UNDERGROUND STORAGE TANK CLEANUP FUND PROGRAM, NO RESPONSE TO LETTER OF COMMITMENT (LOC): CLAIM NUMBER 001138; FOR SITE ADDRESS: 1061 EASTSHORE HWY, BERKELEY

CORRECTIVE ACTION CHRONOLOGY

Re: Request for closure for the site located at 1061 Eastshore Hwy., Albany, California

Re: Phase II Hydrogeologic Assessment Work Plan for Buehrer Albany facility, submitted by Aegis Environmental, Inc.

FIGURE 3. Proposed <u>locations</u> of Monitoring Wells.

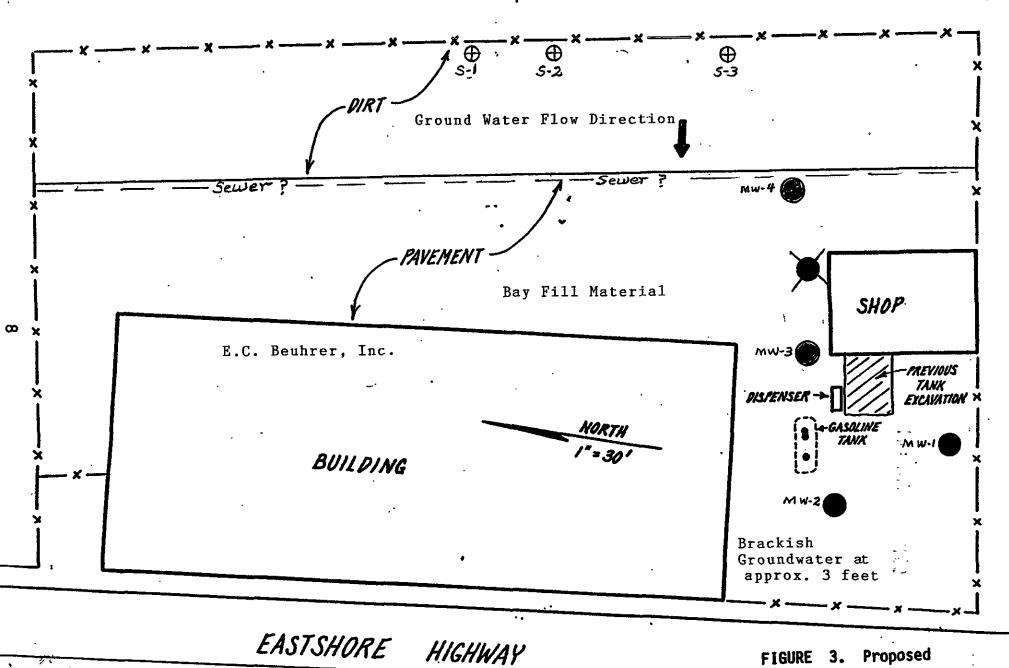
1) Install one additional monitoring well on the easterly boundary of the E.C. Beuhrer, Inc. site. The Hageman-Schank, Inc. work plan included three (3) monitoring wells.

- 2) Aegis recommends that two soil samples be taken, from about three (3) feet below the surface, along the easterly boundary of E.C. Beuhrer, Inc. Leasehold. Aegis recommends analyzing these samples for an E.P.A. "priority pollutant scan" method 8260.
- Aegis recommends that one (1) soil sample be taken, about three (3) feet below the surface, from the area where the old electrical transformer was located. Aegis recommends that this sample be analyzed for PCB's. (See plot plan attached)
